Project No. 2021\_154

MIDLOTHIAN ISD STADIUM ADDITIONS AND RENOVATIONS

ADDENDUM NO. 2

DATE: October 18, 2021

P-101

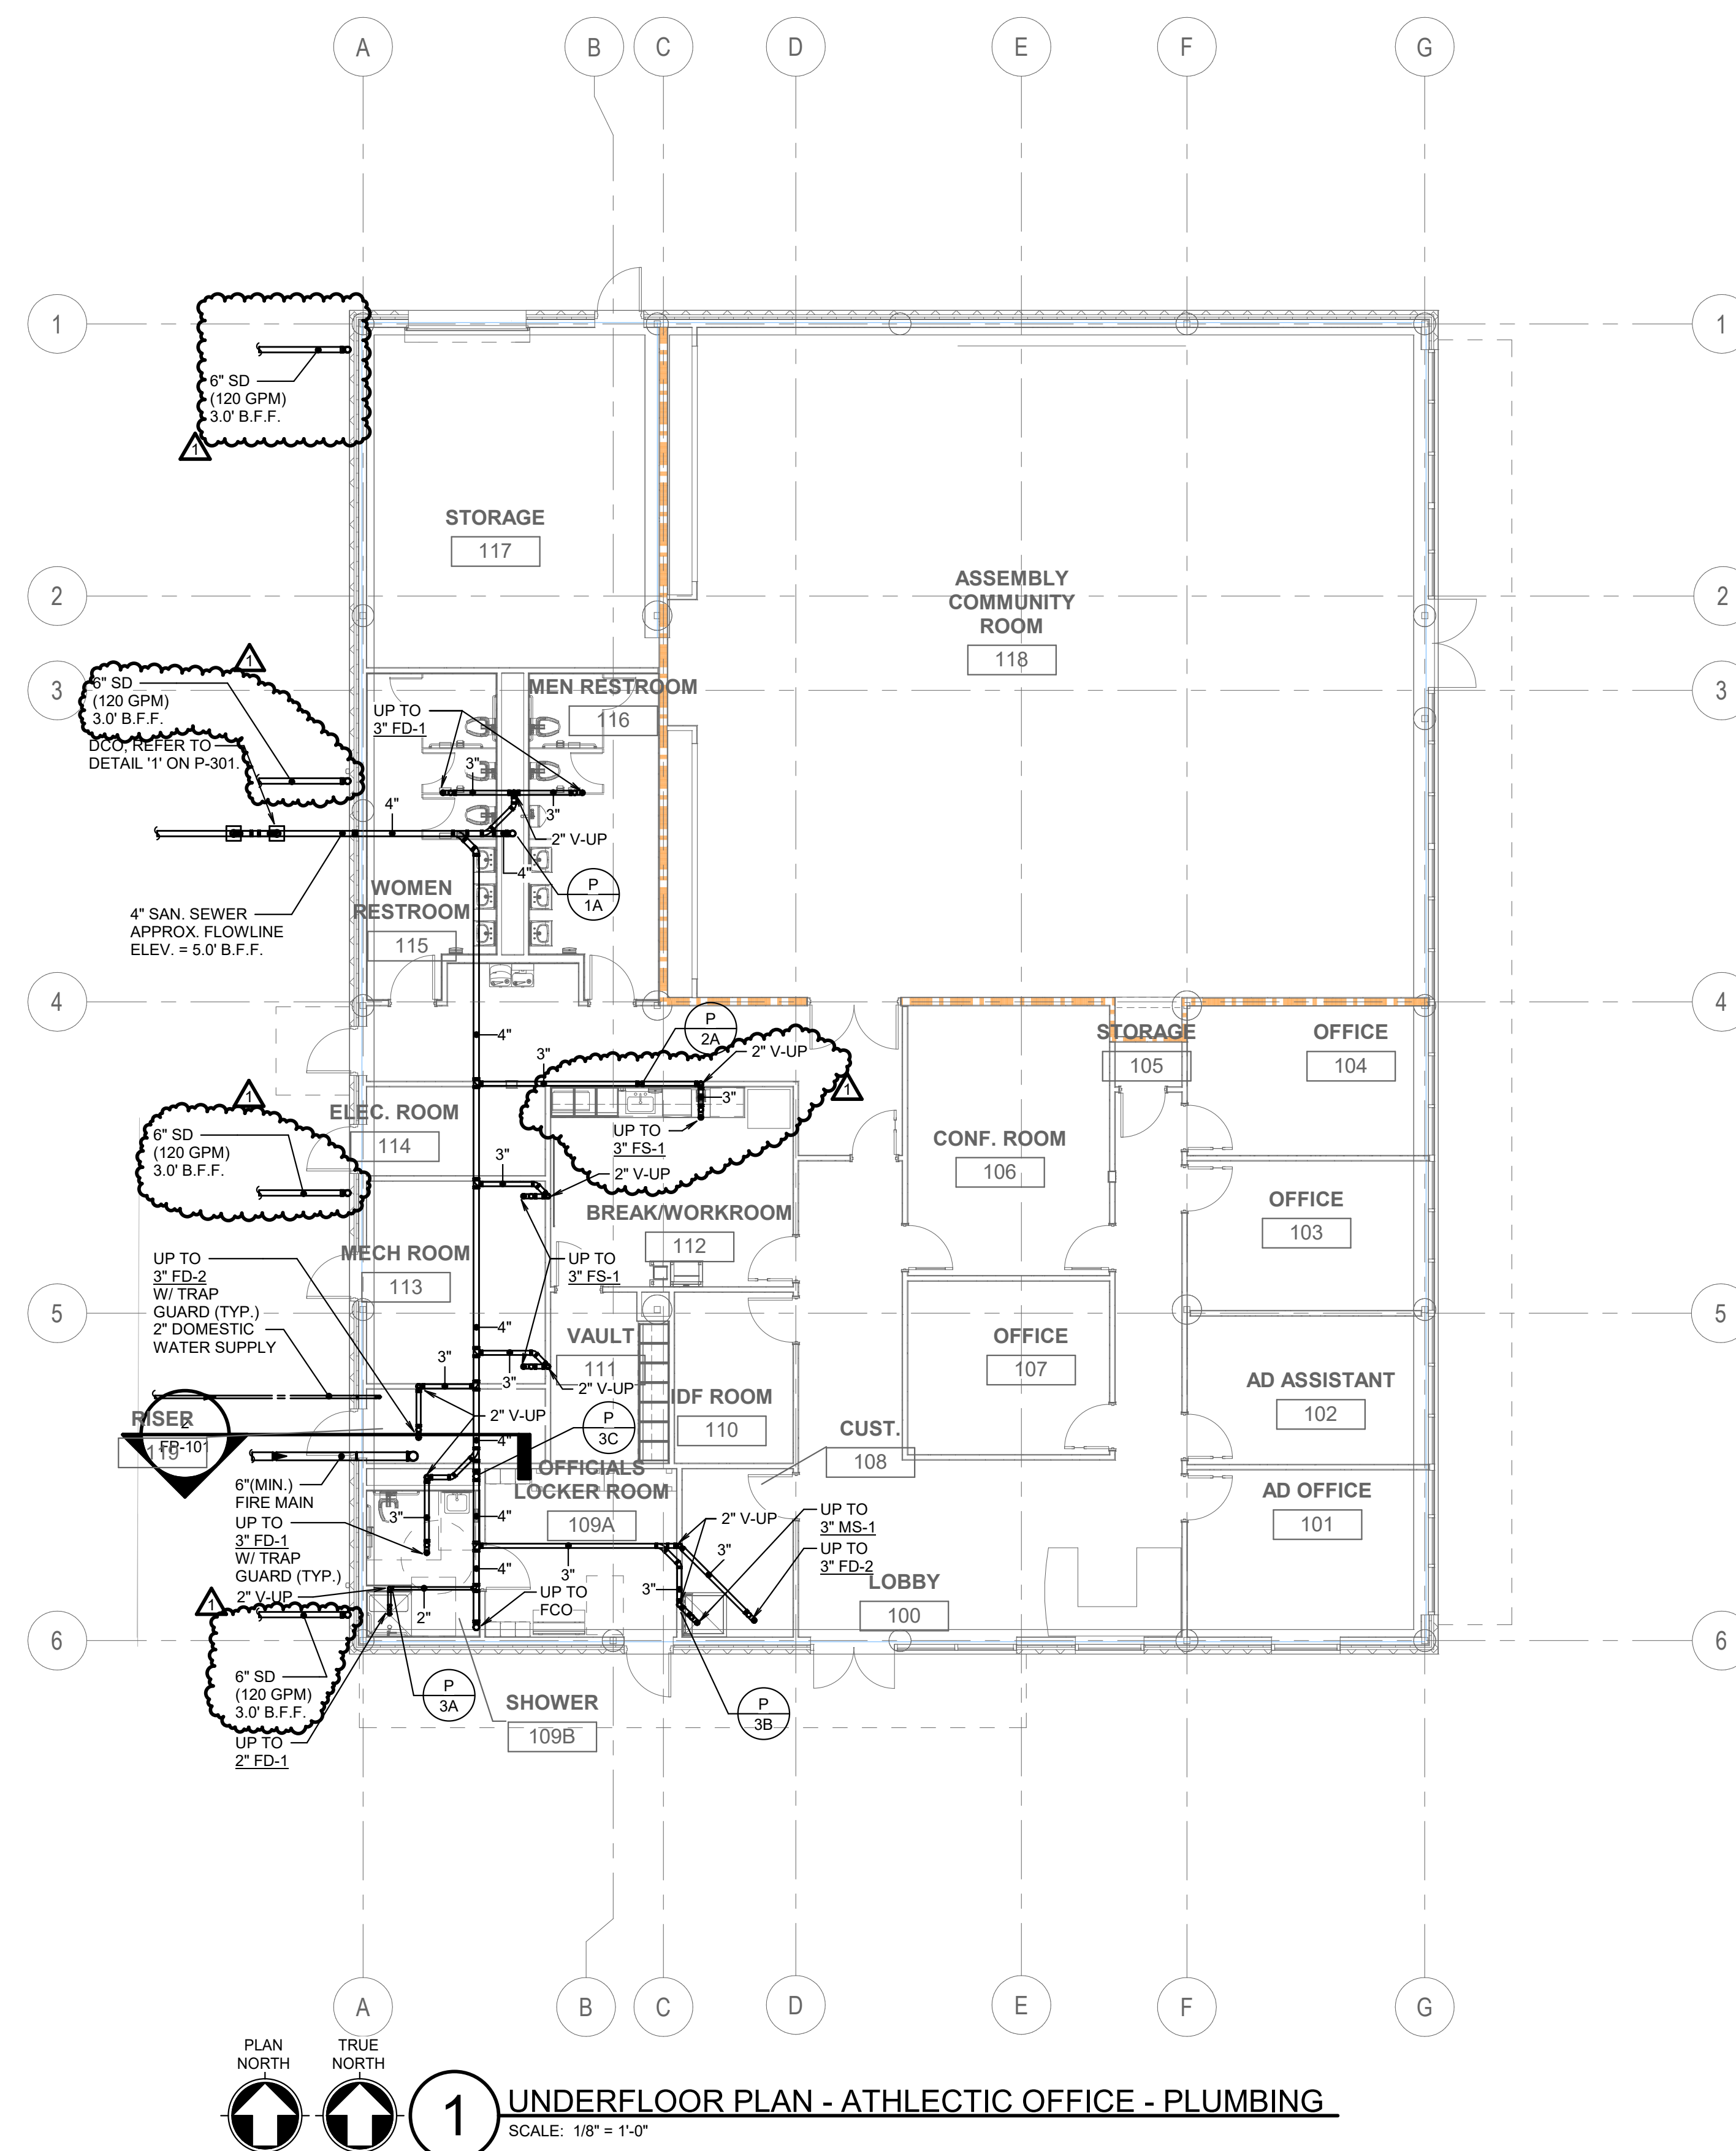
- A2.33 SHEET P-101 – UNDERFLOOR PLAN – ATHLETIC OFFICE – PLUMBING:  
REMOVE and REPLACE in its entirety.  
a. Refer to attached drawing storm drain & sewer revisions at Athletic Office.

PLAN NORTH TRUE NORTH  
1 UNDERFLOOR PLAN - CONCESSION NORTHEAST - PLUMBING  
SCALE: 1/8" = 1'-0"

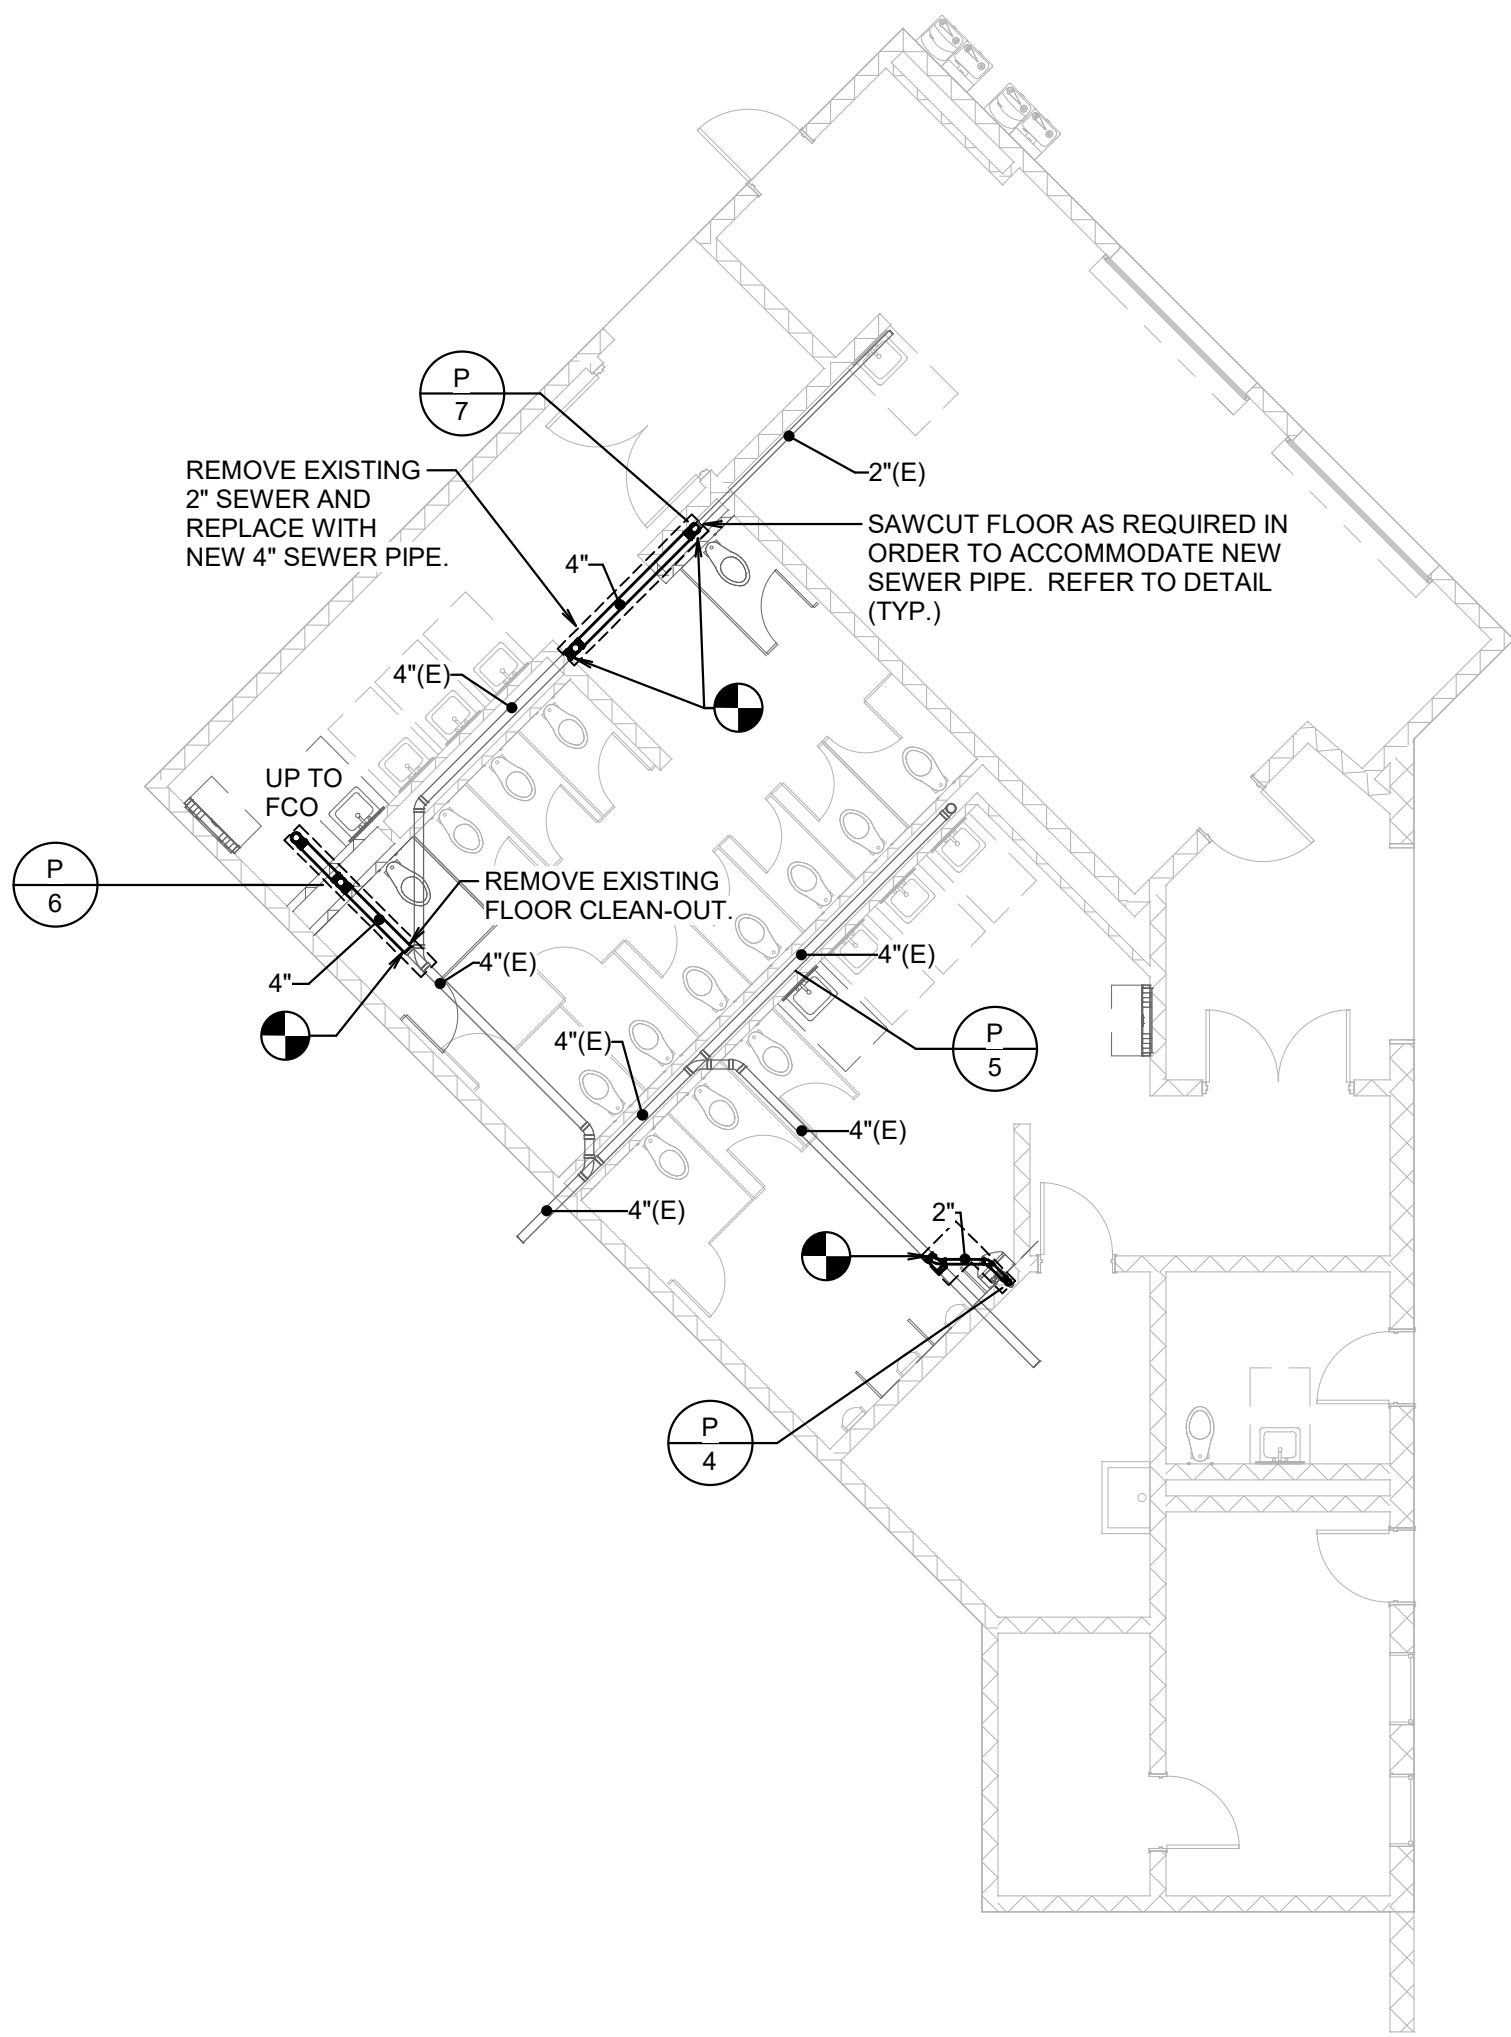
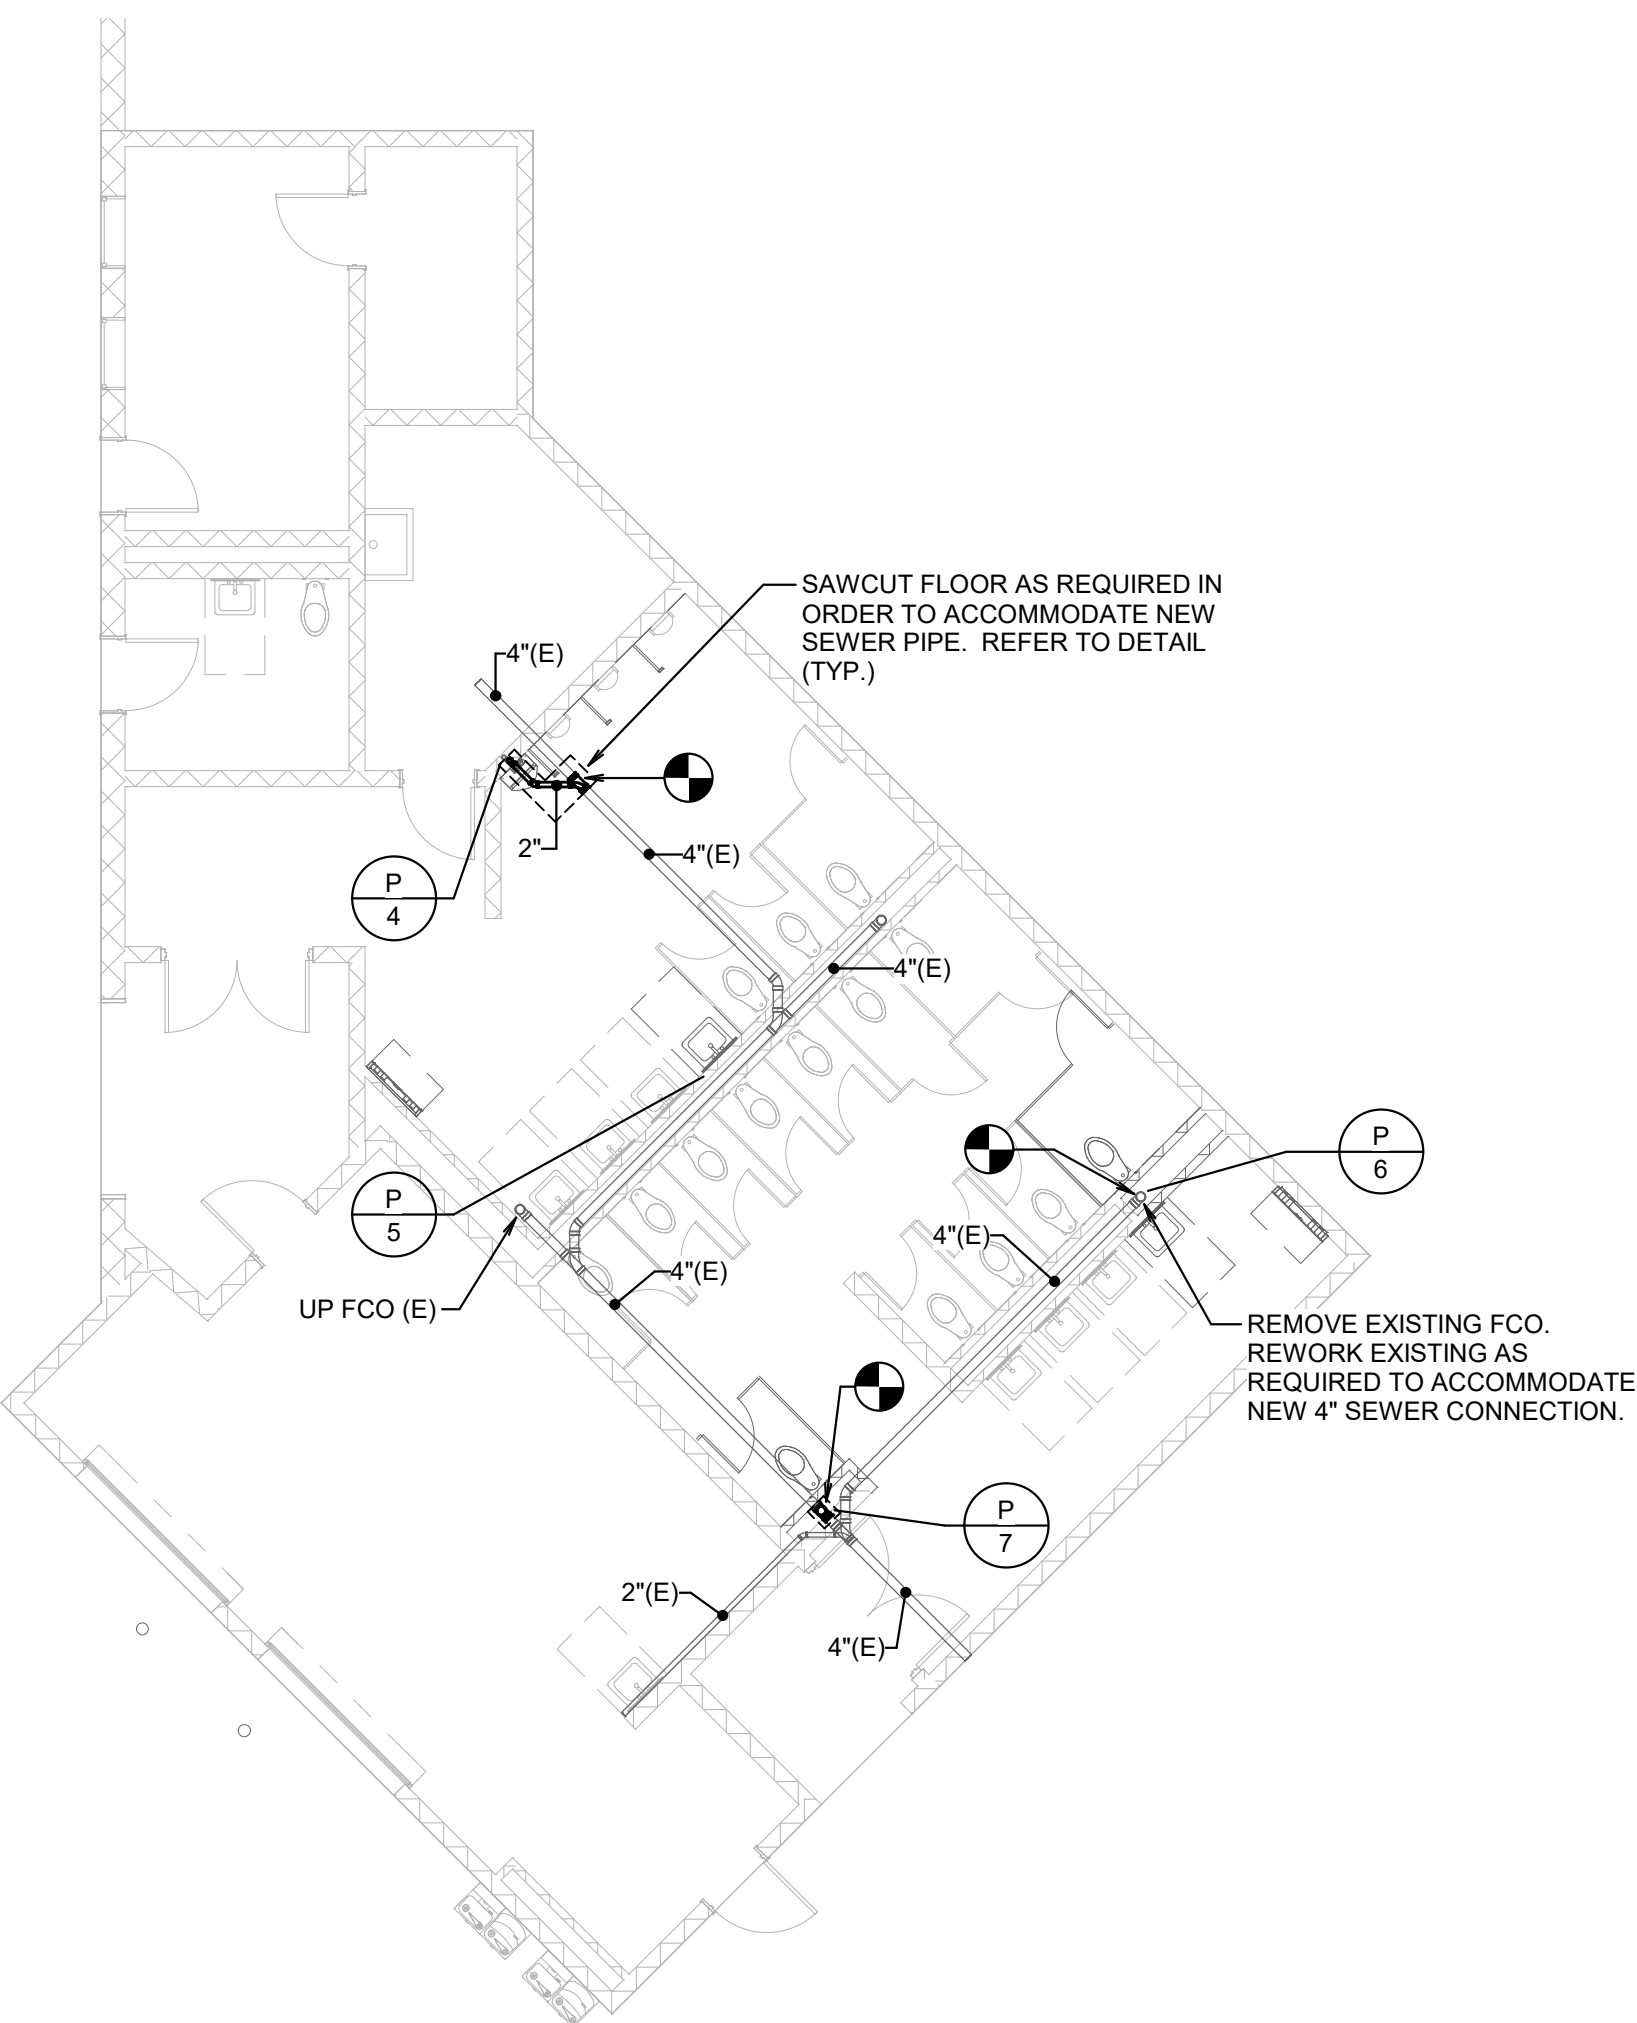
- A2.34 SHEET – P-102 – UNDERFLOOR PLANS – CONCESSIONS - PLUMBING  
ADD in its entirety.  
a. Refer to attached new drawing for ADDED plumbing fixtures at concessions.
